**MINUTES
PLANNING COMMISSION
AUGUST 18, 2020
LAKEWOOD CITY HALL
SPECIAL MEETING
7:00 P.M.
REMOTE MEETING - RECORDED**

**3. Docket No. 08-39-20
12301 Madison Avenue
LBM**

Eric Ho, LBM requests conditional use for temporary expansion of outdoor dining, the flexibility to expand or add outdoor dining to support restaurants that are affected by COVID-19 restrictions; property is in a C2 Commercial - Retail district. Pursuant to Chapters 1161 and 1129 Outdoor Seasonal Dining as temporarily modified by Resolution 2020-31(5-22-2020) until 10-31-2020 (Page 2)

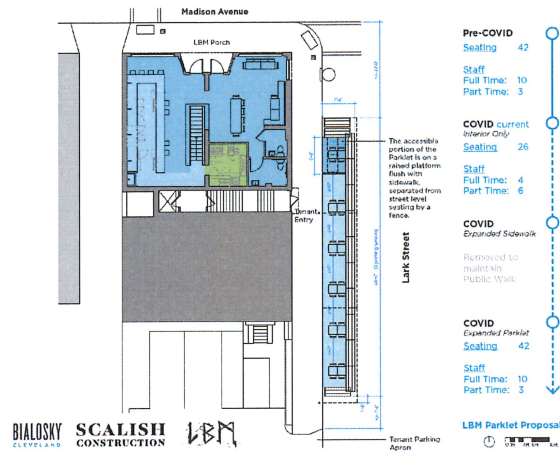
- Temporary Covid -19 approval as proposed for the duration of the temporary period which expires after October 31, 2020. Owner to remove temporary outdoor dining installation by November 1, 2020.
- Barricades must be a minimum of thirty-six (36) inches in height (there is a discrepancy between the site plan and specification sheet).
- To comply with the required buffer zone, Barricades are to placed no more than seven (7) feet from the face of curb.
- The double barricades facing southbound traffic on Lark shall be angled to channelize traffic away from the temporary parklet.
- The temporary parklet is approved for 24 seats and not 42 seats as listed.
- Safety forces has reviewed the plan and has no objections as proposed.
